ADDENDUM NO. 2

DATE: February 15, 2019
FROM: City of Grand Junction Purchasing Division
TO: All Offerors
RE: 2019 Sewer Interceptor Repair and Replacements IFB-4602-19-DH

SOUTH SIDE INTERCEPTOR SEWER (SECTIONS I & II)
PLAN and PROFILE
STA. 68+00 to STA. 76+33 (SECT. I)
STA. 0+00 to STA. 8+00 (SECT. II)

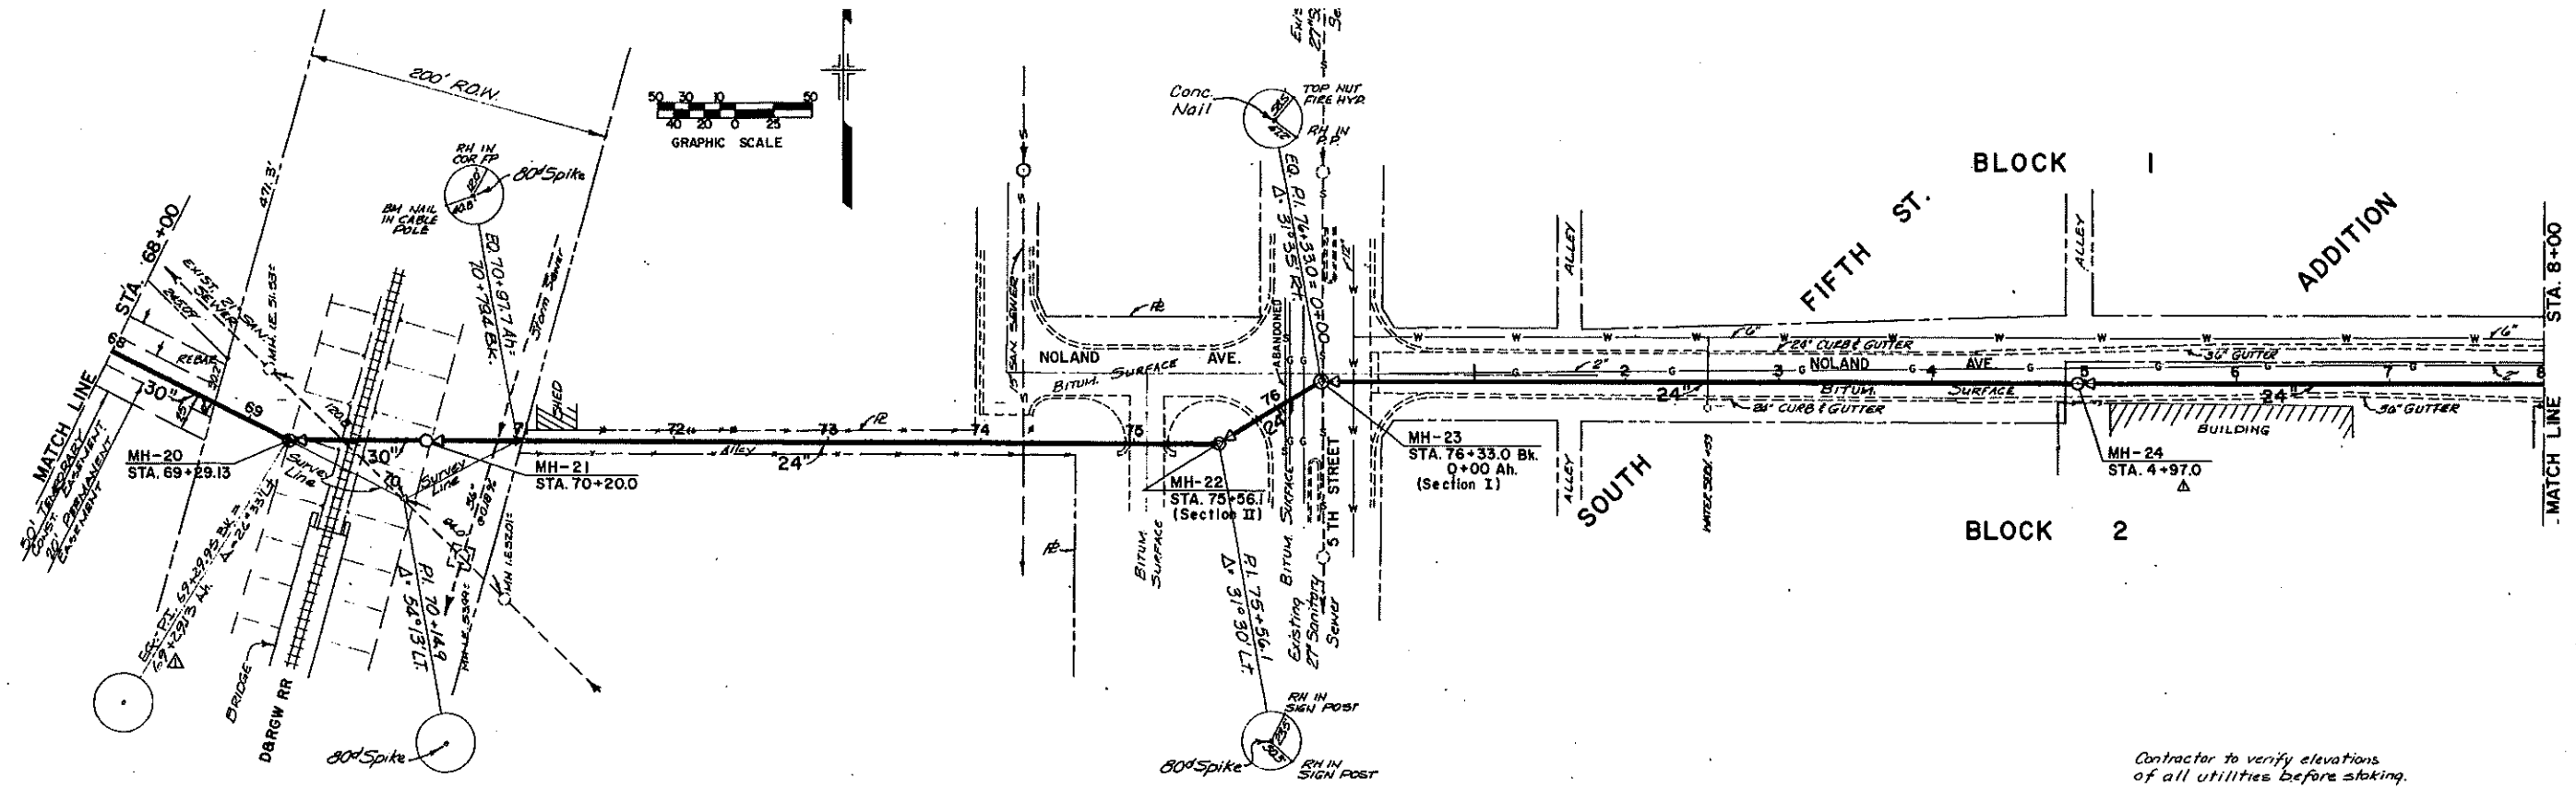
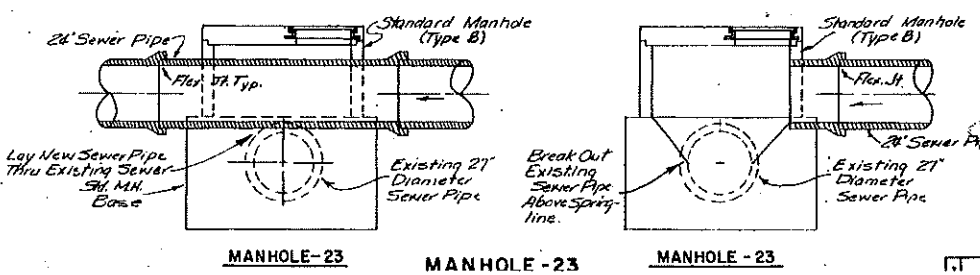
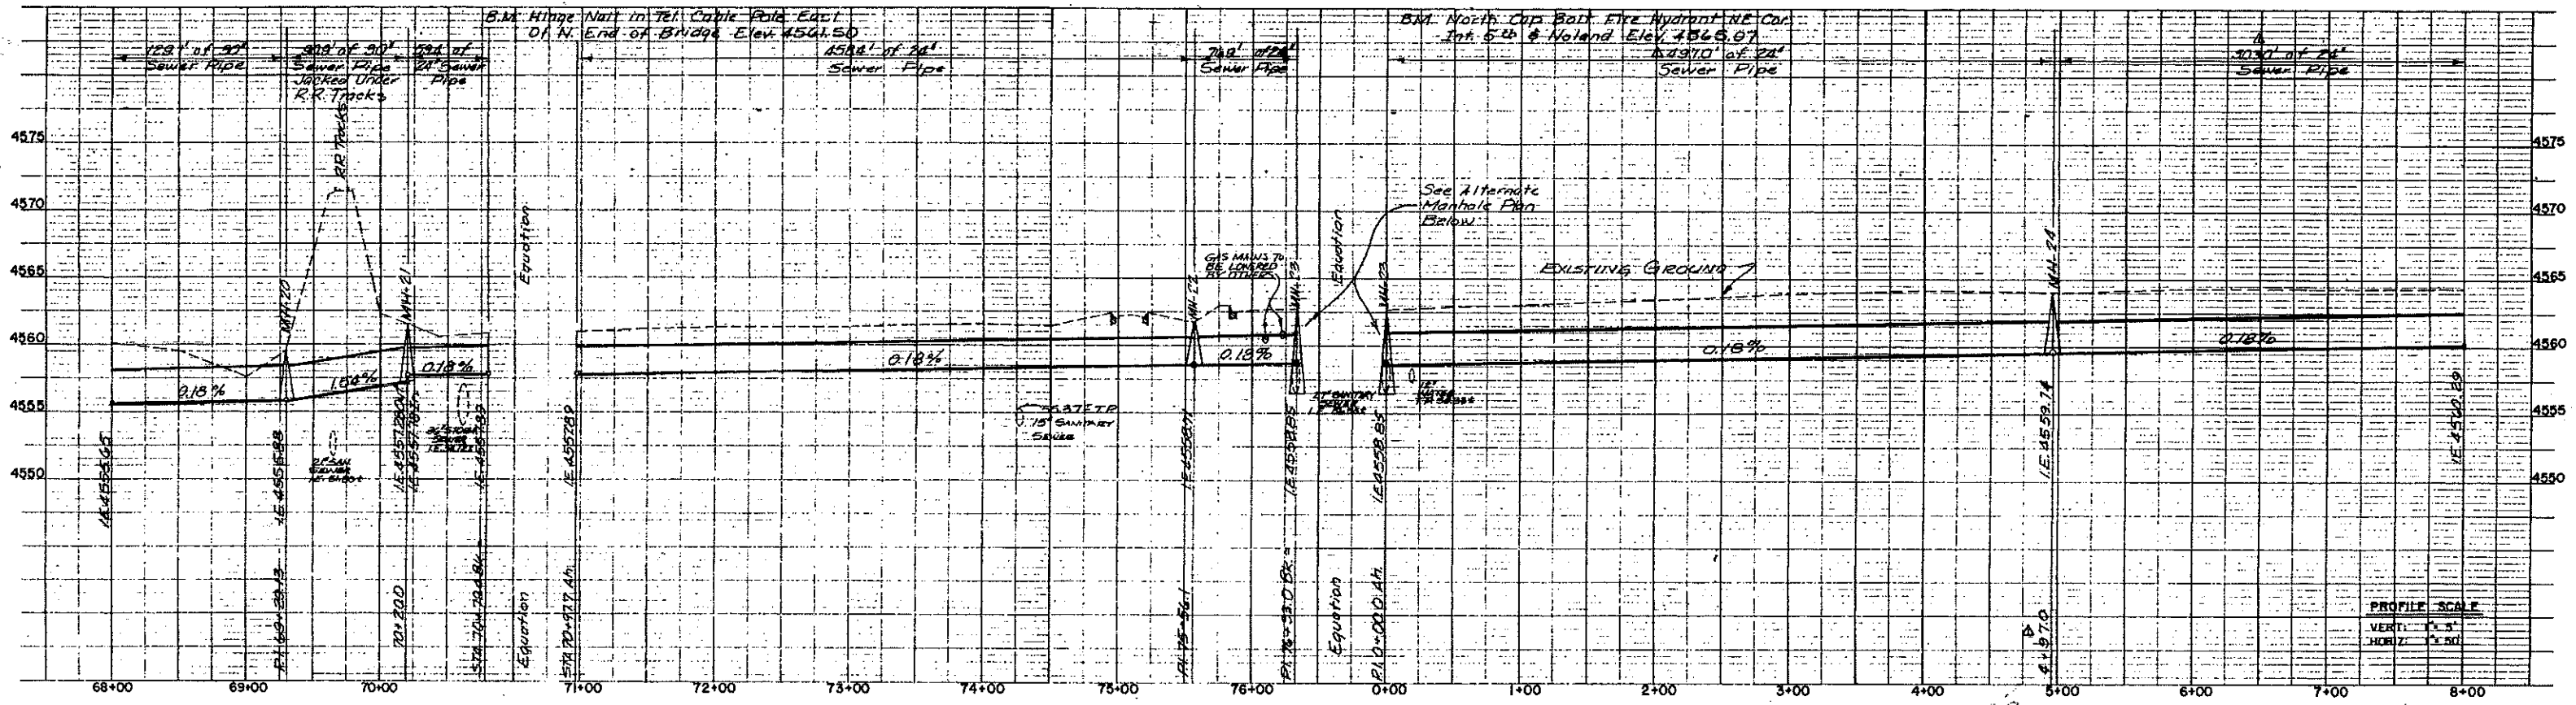
4. Q. Can the City please provide a SS plan upstream of the 24" line where the bypass would start? Refer to map page 19 – MH C3-261-011.

A. Yes. Please see the attached As-Built sheet(s) for the above requested segment.
